Facsimile

Subject: About the improvement of the Noise when using CPT panel in 32" TV

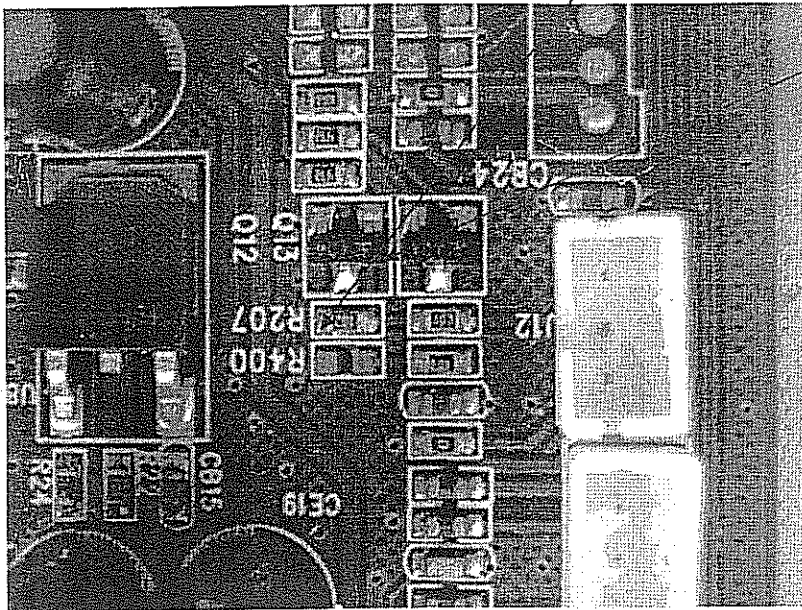
Due to the noise appear when using the CPT (CLAA320WA01-CY) in Jointek 32" LCD TV, It is due to the PWM control of the back light. There is the improvement as below:

1. Delete the Q12
2. Replace the R207 from 1Kohm to 47Kohm.
